Product Change Notice

Series: RW-xxxxS/SMD – modification to the case.

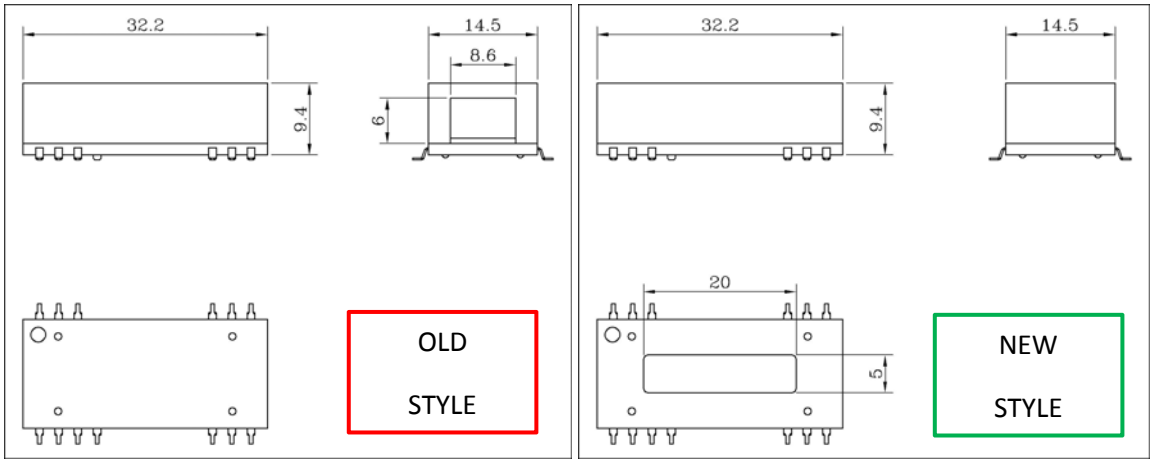
The single output RW series with SMD pinning uses a low profile case style with an end-window for the epoxy potting:

This is not an optimal design for production: the tolerances between the two case halves must be very precise and can easily be damaged, so special handling care must be taken during production.

Furthermore, as the two case ends have different rigidities due to the end window design, there is also a possibility that the case could warp and cause co-planarity errors after end-user reflow soldering.

To improve the yield and reliability, the case will be changed to a bottom-window rather than end-window design:

The change is only to the physical appearance. There is no change to the converter performance, specifications, pin-outs or overall dimensions. The two case versions are fully compatible and interchangeable.

Effective date: from datecode 1440
